# Technical Service Bulletin

SUBJECT:			No: <b>TSB-21-54A-002</b>
<b>SOFTWARE UPDATE FOR SMARTPHONE LINK DISPLAY AUDIO</b>			DATE: <b>June 2021</b>
			MODEL: <b>See below</b>
<b>CIRCULATE TO:</b>	<input type="checkbox"/> GENERAL MANAGER	<input checked="" type="checkbox"/> PARTS MANAGER	<input checked="" type="checkbox"/> TECHNICIAN
<input checked="" type="checkbox"/> SERVICE ADVISOR	<input checked="" type="checkbox"/> SERVICE MANAGER	<input checked="" type="checkbox"/> WARRANTY PROCESSOR	<input type="checkbox"/> SALES MANAGER

A software update is now available for the Smartphone Link Display Audio (SDA). This update resolves several issues that may occur in various models equipped with SDA, as listed below.

## DISPLAY AUDIO SOFTWARE VERSION CHART

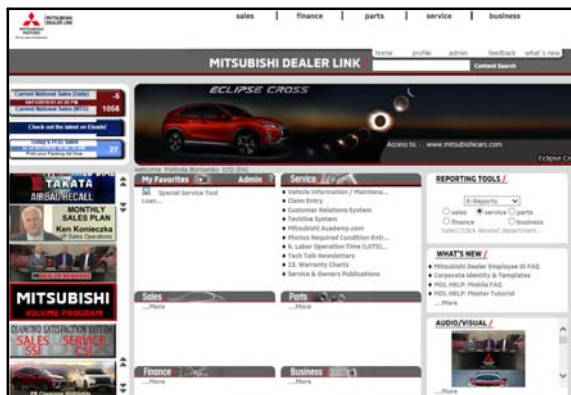
Model	Version Information (Settings screen)		Software Version Info (Service Menu screen)
	Old	New	
2020 Outlander, Outlander PHEV and Outlander Sport / RVR	4.36	4.37	0.0085.P003
